UNITED STATES PATENT AND TRADEMARK OFFICE

10/803,051

Office Action Summary	Application No. 10/803,051	Applicant(s) PLANTAN, RONALD S.	
	Examiner Melody M. Burch	Art Unit 3683

DETAILED ACTION

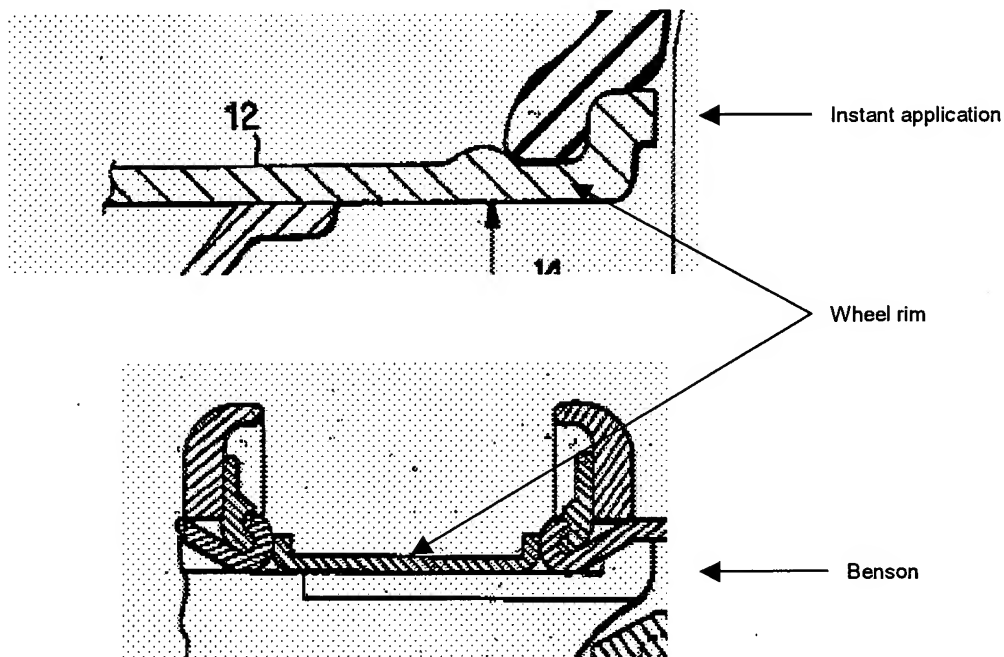
6. Applicant's arguments filed 2/8/06 have been fully considered but they are not persuasive. Applicant argues that "there is no question that Benson's flange 13 extends to a radially outer portion of friction ring 19, and thus does not disclose or suggest the invention in claims 1 and 16." Examiner notes that the portion of the flange 13 in the area of the lead line of number 13 extends from a radially outer region of the hub portion 7 to a radially inner region of the friction portion 19 in the same manner in which one would extend their arms up to the ceiling. A person extends their arms to the ceiling but does not necessarily touch the ceiling. There is nothing in the claim language that precludes such an interpretation. The claim language does not recite an extension that ends in a direct connection. Accordingly, Examiner maintains that, as broadly recited,

the portion of the flange 13 in the area of the lead line of 13 extends to a radially inner region of the friction portion 19.

Also, with regards to the wheel rim, just as Applicant's wheel rim includes a flat piece with crimped edges, Examiner has interpreted the wheel rim of Benson to be the flat piece with crimped edges as labeled below:
